Item 4.**Development Application: 110-122 Oxford Street, Darlinghurst - D/2020/1072**

File No.: D/2020/1072

Summary

Figure 2: The original proposal of Group 1 at the left, Group 2 in the centre (both proposed under D/2020/1071) and Group 3 at the right (proposed under D/2020/1072) viewed from Oxford Street (Note: Groups 1 and 2 are not the subject of this report)

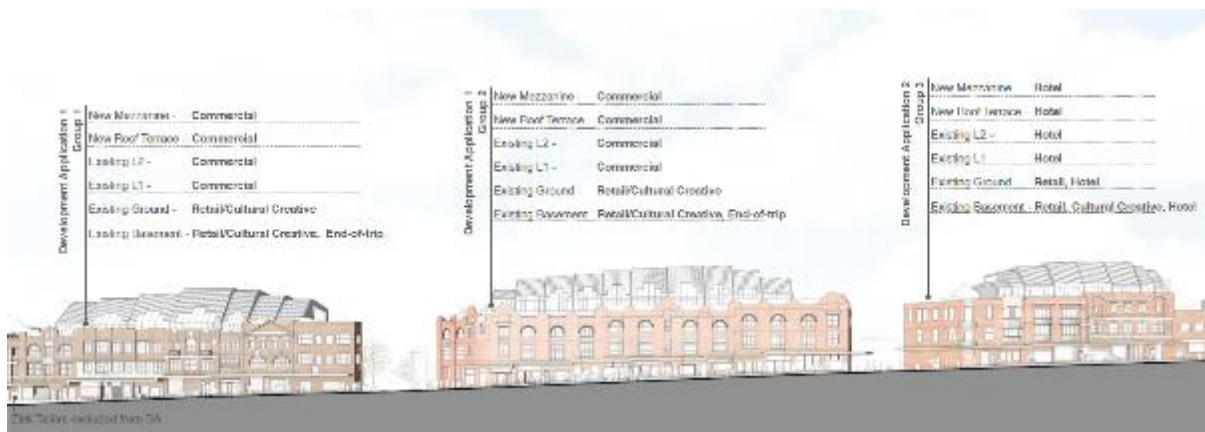
12. Subsequent to the deferral of the application a set of amended plans were submitted to address the comments made by the Local Planning Panel.
13. An amended Clause 4.6 variation request, view loss study and design report were also submitted. The amendments to Group 3 are summarised below:

- (a) The stepping of the new rooftop additions amended to relate to the existing Oxford Street facade.
 - (b) Rooftop additions to be clad in a copper coloured zinc sheeting to differentiate Group 3 from Groups 1 and 2.

- (c) The skylight strips removed from the roof/facade junction and replaced with a curved profile clad in the roof sheeting.
 - (d) Relocation of residential bin room at lower ground floor level.

Figure 5: External louvres (outlined in red)

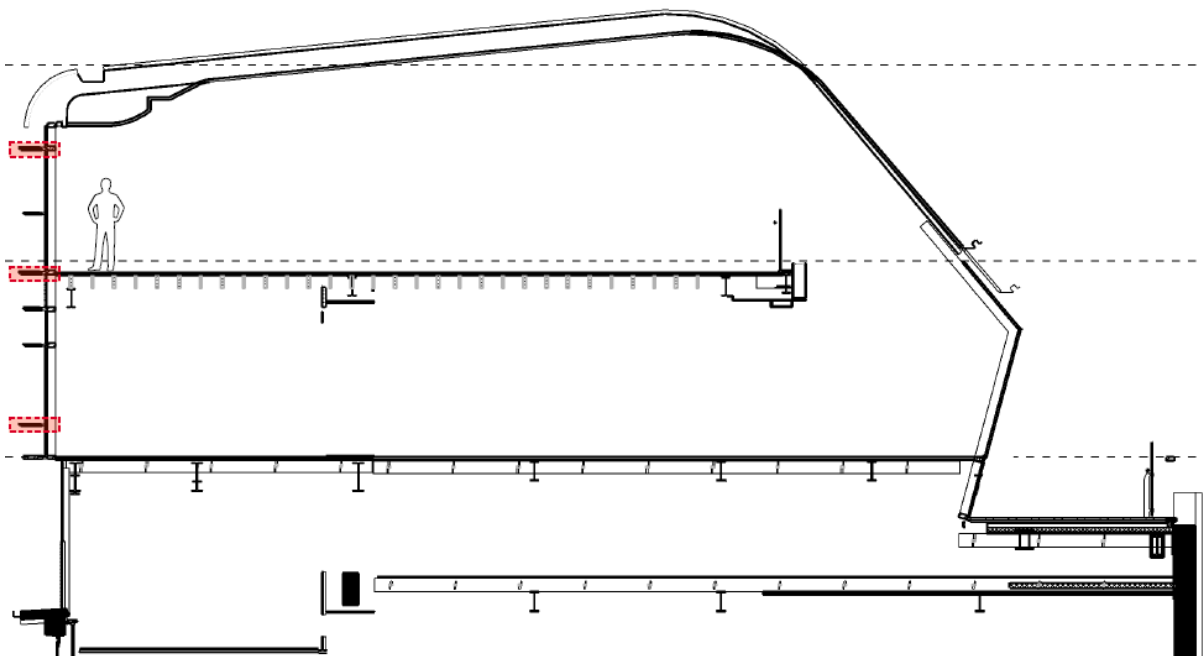
Environmental Performance	<p>The extent of glazing and detailing of the glazing is refined to enhance the environmental performance of the building. The amendments include:</p> <ul style="list-style-type: none"> • Increased sun shading on the northern facade to 450mm louvres. • Reduced roof glazing, minimising the heat loads on the internal office space through reduced window openings. • The integration of metal mesh interlayer in the roof glazing to enhance the passive sun shading of the glazing, further reducing heat loads and need for air conditioning. <p>The proposal achieves a 4 star NABERS rating. This is consistent with the requirements of Section 3.6 of the Sydney DCP 2012 which outlines that a 5 star NABERS rating is not required where the upgrade works would negatively impact on significant heritage fabric or the heritage significance of a heritage item.</p>

Figure 6: Location of louvres for Group 3 (outlined in red)

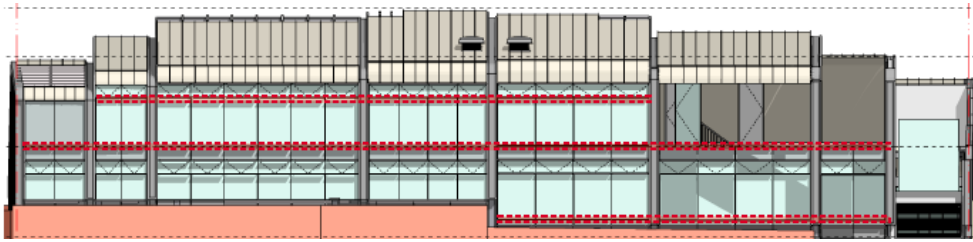
Design Advisory Panel Recommendations	Design response
<p>The Panel is also concerned about the amenity and environmental performance of the building. Investigations should include treatments / setback on Foley Street to achieve better environmental performance. Investigations could include the provision of roof terraces on Foley Street to capitalise on the potential views to the harbour.</p>	<p>The extent of glazing and detailing of the glazing is amended to enhance the environmental performance of the building. The amendments include:</p> <ul style="list-style-type: none"> • Increased sun shading on the northern facade to 450mm louvres. • Reduced roof glazing, minimising the heat loads on the internal office space through reduced window openings. • The integration of metal mesh interlayer in the roof glazing to enhance the passive sun shading of the glazing, further reducing heat loads and need for mechanical conditioning. <p>The proposal achieves a 4 star NABERS rating. This is consistent with the requirements of Section 3.6 of the Sydney DCP 2012 which outlines that a 5 star NABERS rating is not required where the upgrade works would negatively impact on significant heritage fabric or the heritage significance of a heritage item. The proposal was reviewed by Council's environmental advisor and is satisfactory.</p> <p>The louvres provide additional screening and privacy to neighbouring properties and prevent downward overlooking, while maintaining a suitable outlook from the proposed development.</p> <p>A provision of a roof terrace facing Foley Street is inconsistent with the draft DCP provisions, which allow a nil setback to the Foley Street frontage, and was therefore not pursued.</p>

32. The amended proposal achieves an appropriate design outcome that responds to the issues raised by the Panel, and is therefore recommended for approval.

Figure 12: Sections through Group 3. The red lines indicate the current Sydney LEP 2012 height control.

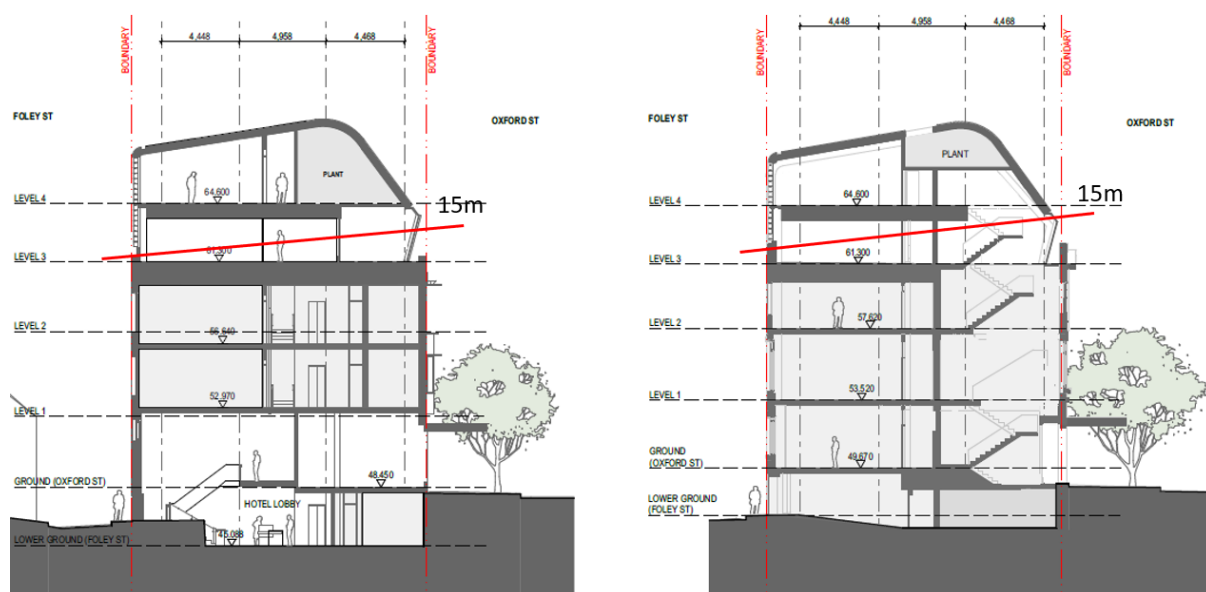
Provision	Compliance	Comment
		<p>A height of 21.9 metres is proposed for Group 3.</p> <p>A request to vary the height of buildings development standard in accordance with Clause 4.6 has been submitted.</p> <p>The additional height is recommended for support and this is assessed further in the 'Discussion' section below.</p>
4.4 Floor space ratio (FSR)	Yes	<p>A maximum FSR of 4:1 is permitted for the site as per clause 4.4 of the Sydney LEP 2012.</p> <p>A FSR of 4:1 is proposed, which complies with the relevant standard.</p>
4.6 Exceptions to development standards	Yes	<p>The proposed development seeks to vary the development standard prescribed under Clause 4.3 height of buildings.</p> <p>An amended Clause 4.6 variation request has been submitted with the amended application.</p> <p>This is assessed further in the 'Discussion' section below.</p>

64. The applicant's written request adequately addresses the matters required for demonstration by Clause 4.6(3)(a) and (b) of Sydney LEP 2012.
65. A detailed discussion regarding the objectives of the height of buildings development standard has been provided and satisfies the test under Clause 4.6(3)(a), such that compliance with the standard is considered to be both unreasonable and unnecessary, to the extent of the variations proposed.
66. The applicant has satisfactorily demonstrated that there are sufficient environmental planning grounds to contravene the development standard which satisfies the test under Clause 4.6(3)(b). As such, the requirement of clause 4.6(4)(a)(i) of Sydney LEP 2012 is met.

Figure 14: A typical setback for Group 3, with the area of setback non-compliance shown in purple, and the maximum draft height shown in red

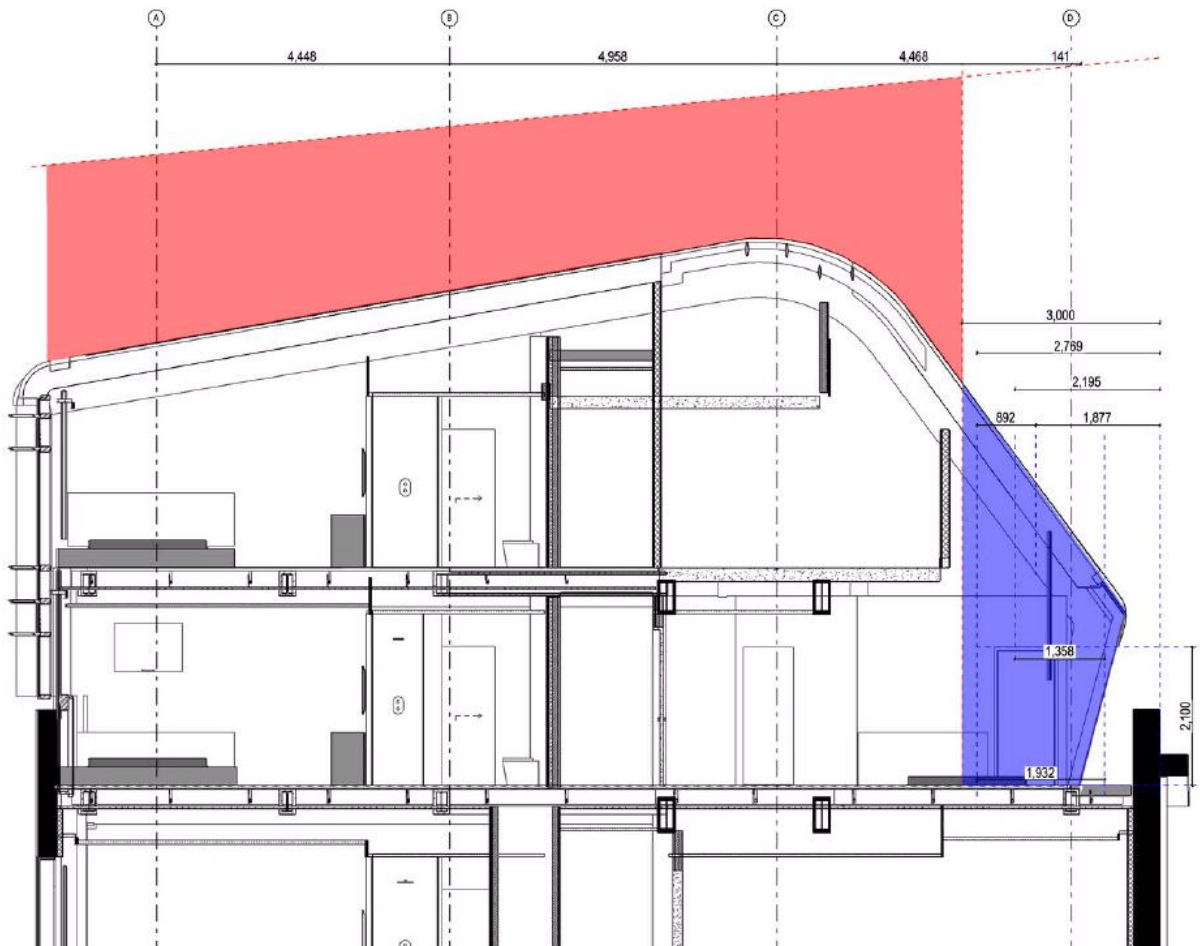
83. Setback analysis has been outlined in the figures below, and these provide comparisons between the proposed development and the alternative built form.

84. The increased alternative built form is considered to result in an undesirable streetscape outcome. The modelling provided by the applicant has demonstrated that the proposed scheme with a lower height and 500mm-550mm setback is a superior design strategy in comparison to a scheme that maximised the height and was compliant with the setback control. Therefore the proposed non-compliance is acceptable.

Figure 25: Modelling from applicant's view loss study, as viewed from roof terrace of 130-132 Oxford Street

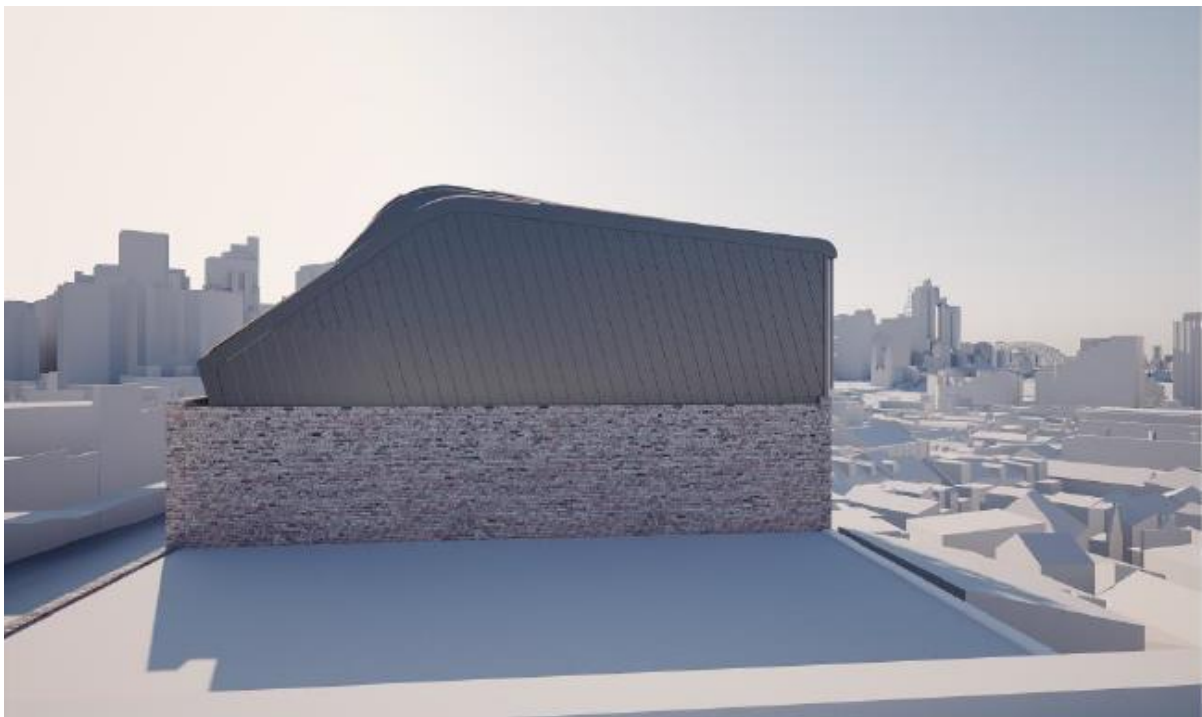
96. 130-132 Oxford Street is located 17 metres to the east of Group 3.
- (a) Views to be affected: Views of the city skyline.
 - (b) Part of property viewed from: Views are from a communal roof terrace to hotel below.
 - (c) Extent of impact: The City skyline is obstructed. Views to the Sydney Harbour Bridge are retained from some vantage points of the roof terrace.
 - (d) Reasonableness: The views are obtained directly over the side boundary towards Group 3, and accordingly views are more difficult to retain with any increase in height of the subject site. It is also noted that 130-132 Oxford Street also benefits from an alternative height of buildings control under the exhibited planning proposal. In the above context, the view impacts of the proposal are reasonable in this instance.

Figure 29: Modelling from applicant's view loss study, as viewed from Level 4 of 200 Campbell Street

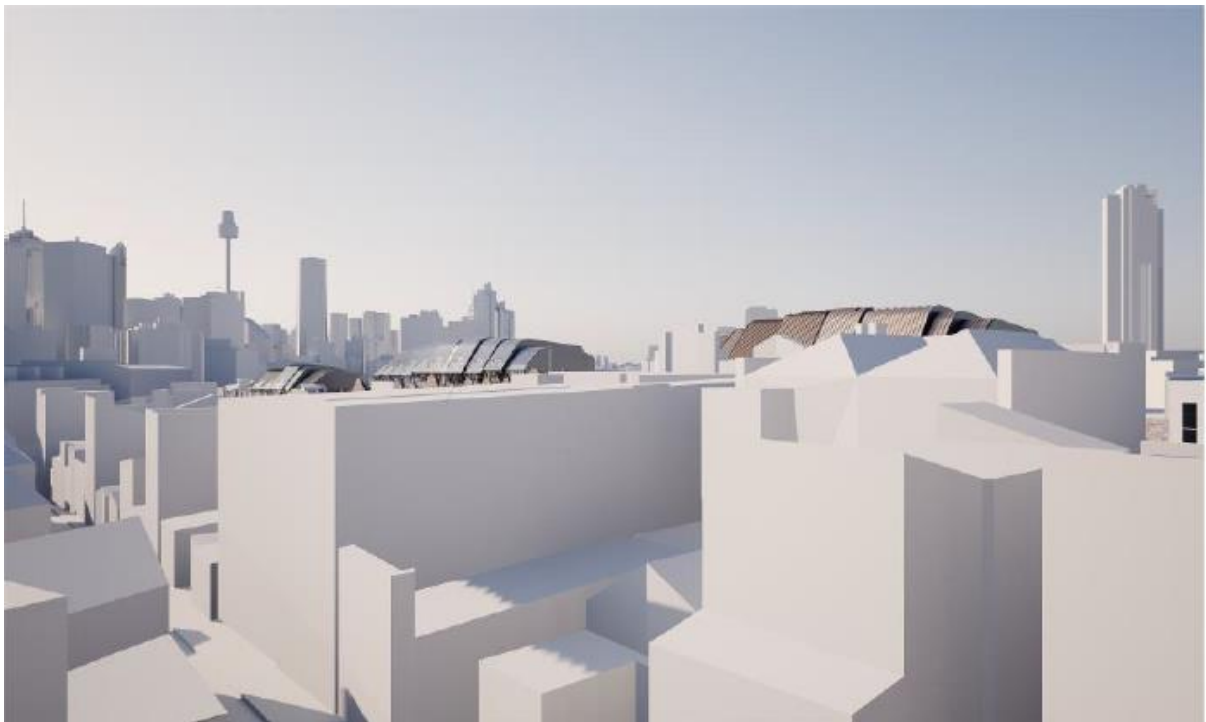
- (d) Reasonableness: The view impacts of the proposal vary depending on the level of the building. Both sides of Oxford Street benefit from an alternative height of buildings control under the exhibited planning proposal. In the above context, the view impacts of the proposal are reasonable in this instance.
